[Docket No. 2000-NM-94-AD; Amendment 39-11712; AD 2000-09-04]

#### Airworthiness Directives; Boeing Model 767 Series Airplanes Equipped with General Electric Model CF6-80C2 Series Engines

**ACTION:** Final rule; request for comments.

Electro-Mechanical Brake and CDU Cone Brake Torque Check  
Figure 1

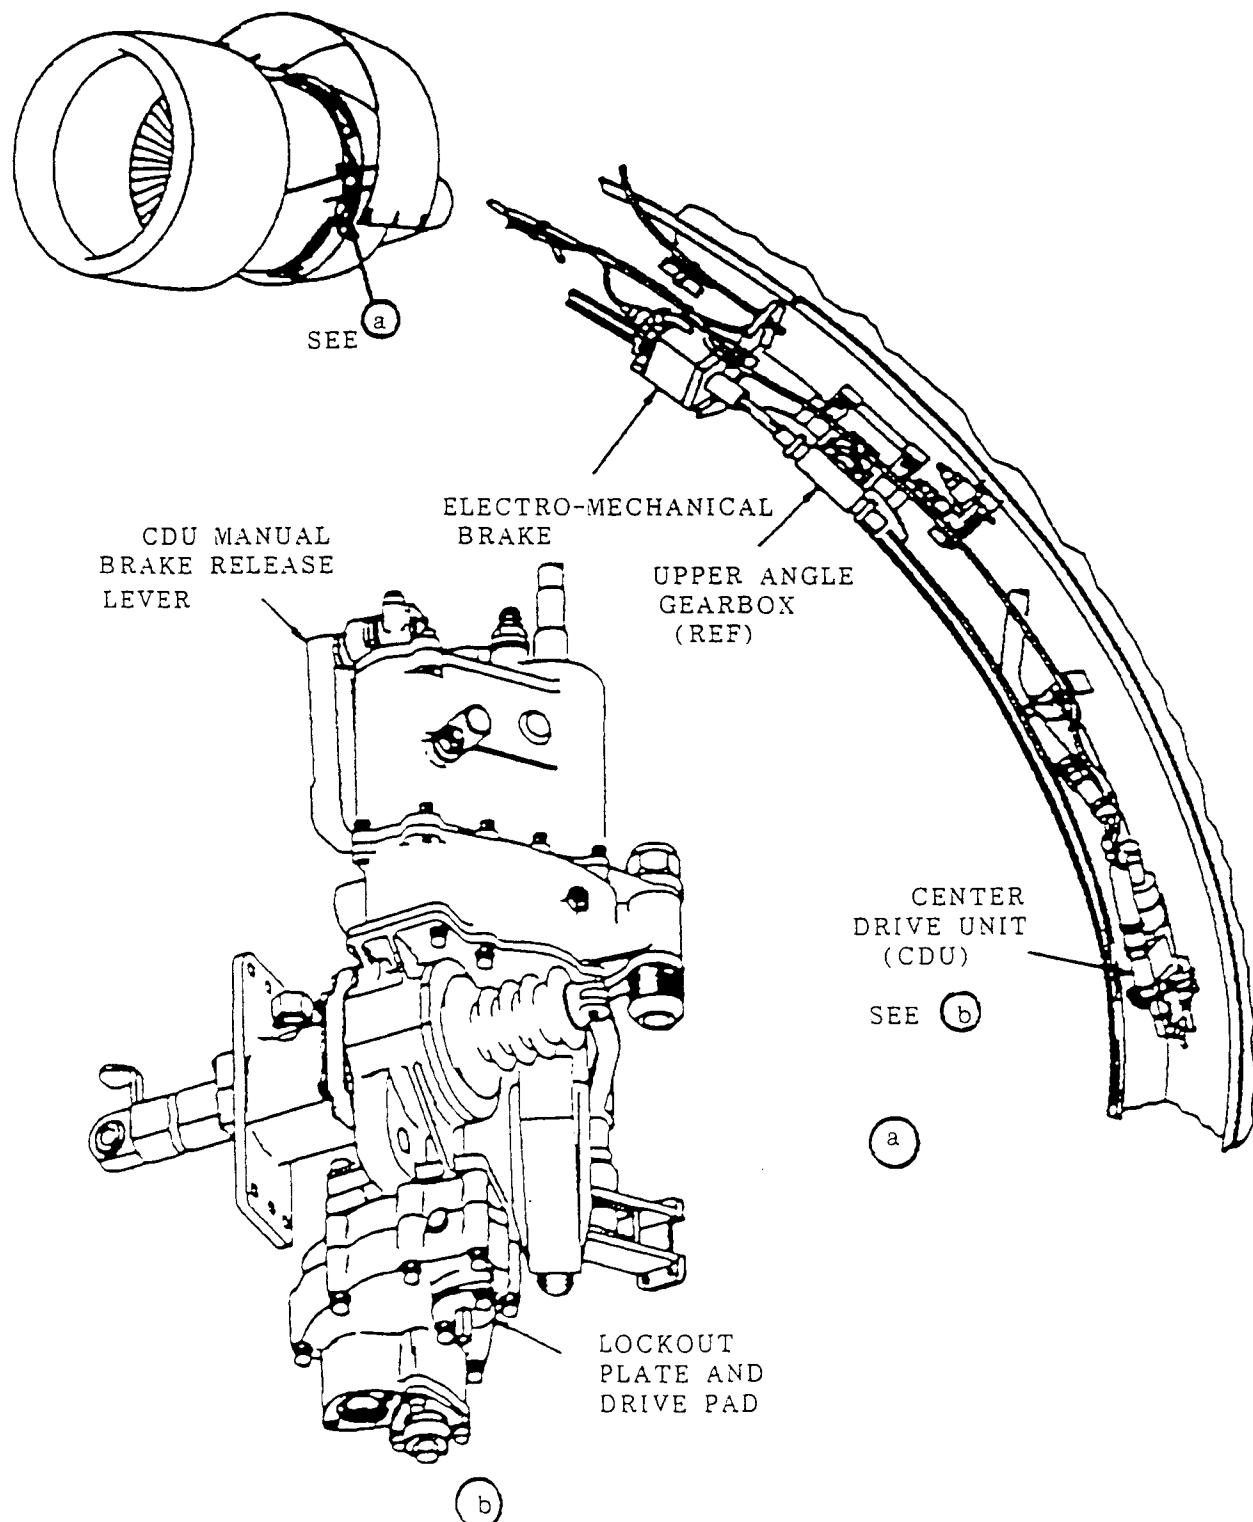
##### *2. Electro-Mechanical Brake and CDU Cone Brake Torque Check (Fig. 1)*

(e) Apply 90 pound-inches of torque to the system.

(1) The electro-mechanical brake system is working correctly if the torque is reached before you turn the wrench 450 degrees (1 1/4 turns).

(2) If the flexshaft turns more than 450 degrees before you reach the specified torque, you must replace the long flexshaft between the CDU and the upper angle gearbox.

(3) If you do not get 90 pound-inches of torque, you must replace the electro-mechanical brake.

**CAUTION: DO NOT USE MORE THAN 100 POUND-INCHES OF TORQUE WHEN YOU DO THIS CHECK. EXCESSIVE TORQUE WILL DAMAGE THE CDU.**

(6) Turn the torque wrench to try to manually extend the translating cowl until you get at least 15-pound inches.

(a) If the torque is less than 15-pound-inches, you must replace the CDU.
